Response To Öko-Institut

1st Questionnaire Exemption No. 2(a)(1-5) (renewal request)

“Exemption for „ Mercury in double-capped linear fluorescent lamps for general lighting purposes not exceeding (per lamp):

Date of submission: September 15, 2015

Figure 1: Weighted average Collection Rate Lamps (all lamps): 2010 – 2013 (blue) and targets 2016-2019 (red)

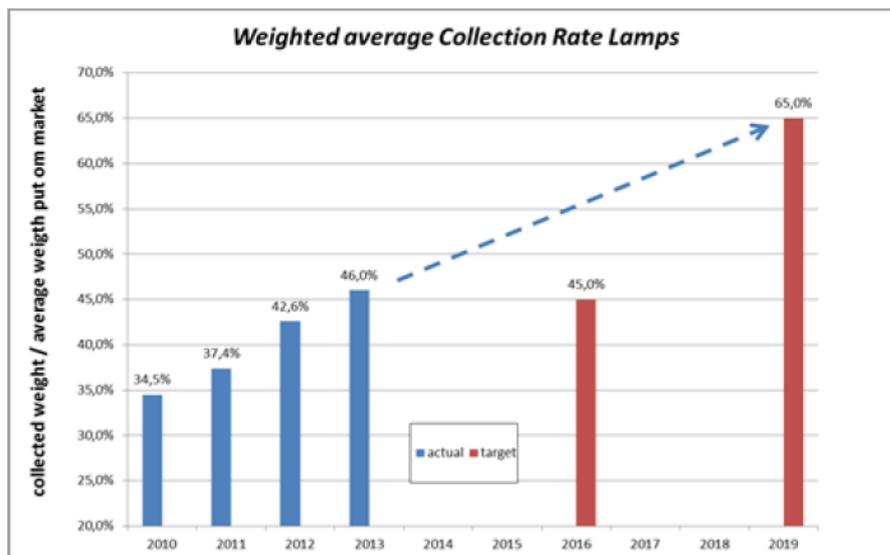
5. Information is provided regarding the total collection and recycling rates of lamps. Data is not specified regarding these rates for every lamp category (entries a-e of Ex. 1) on a quantifiable basis, though various estimations are provided regarding the amount of lamps placed on the market per year and how they are expected to decrease between now and 2020. Among others the following diagram is presented:

- a. Please explain what the denominator of estimated collection/recycling rates is, as it is clear that the number of lamps at end-of-life in a specific year is a result of lamps placed on the market in the past and their respective service-life.

- b. Please explain the discrepancies between these numbers and the numbers mentioned in the VITO & VHK⁷ report regarding collection rates, which provides data in Table 52 showing that the collecting rates of “lighting equipment except for discharge lamps” are around 5% whereas for “discharge lamps... *The fraction collected is around 30% for all years.*” If your data basis shows that higher collection rates are achieved for discharge lamps of various sorts, please support your argumentation with sufficient information as data.

Answer of LightingEurope: The WEEE recast directive (Directive 2012/19/EU)⁶ describes how the collection rate should be measured in Article 7: “The collection rate is to be based on the total weight of WEEE collected in accordance with Articles 5 and 6 in a given year in the member state concerned and expressed as *the percentage of the average weight of EEE placed on the market in the preceding three years in the member state*”. For example the data point from 2010 is based on data from 2007, 2008 and 2009.

Answer of LightingEurope: The report from the VITO & VHK study (Task 3⁸) was issued after the renewal requests were submitted to DG environment. The first percentage mentioned in the question (5%) refers to luminaires and does not apply to lamps. The explanation provided in the report below table 52 indicates that data are lacking and numbers used in the report are partly based on interpretation. LightingEurope numbers (which are the basis for the indicated graph) can be traced to the individual member countries in Europe and are followed over a long period.

Figure 2: Material composition of a Fluorescent luminaire

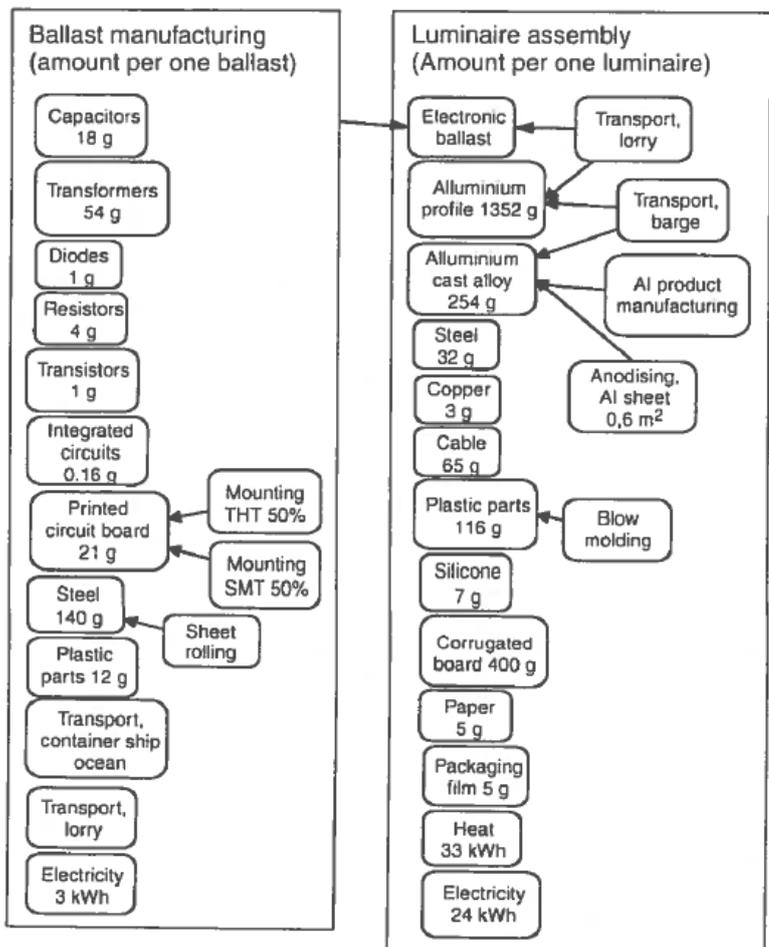
6. It is explained that without the renewal of the exemption, installed linear fluorescent luminaires would need to be scrapped once a lamp malfunction is encountered, in cases where a suitable substitute is not available for retrofit/conversion/rewiring does. It is estimated that this would lead to large environmental impacts. Please clarify what materials and quantities are typically present in T2, T5 and T8 linear fluorescent luminaires.

Answer of LightingEurope: In the luminaire the following materials and components are present: copper iron aluminium, electronic components, electrical wiring, and plastics. The amounts are reported in the following independent study "Life cycle assessment of a fluorescent lamp luminaire used in industry-a case study"⁹. A snapshot of the table with the materials is shown in Figure 2¹⁰. Overall the material difference per application is estimated to be low.
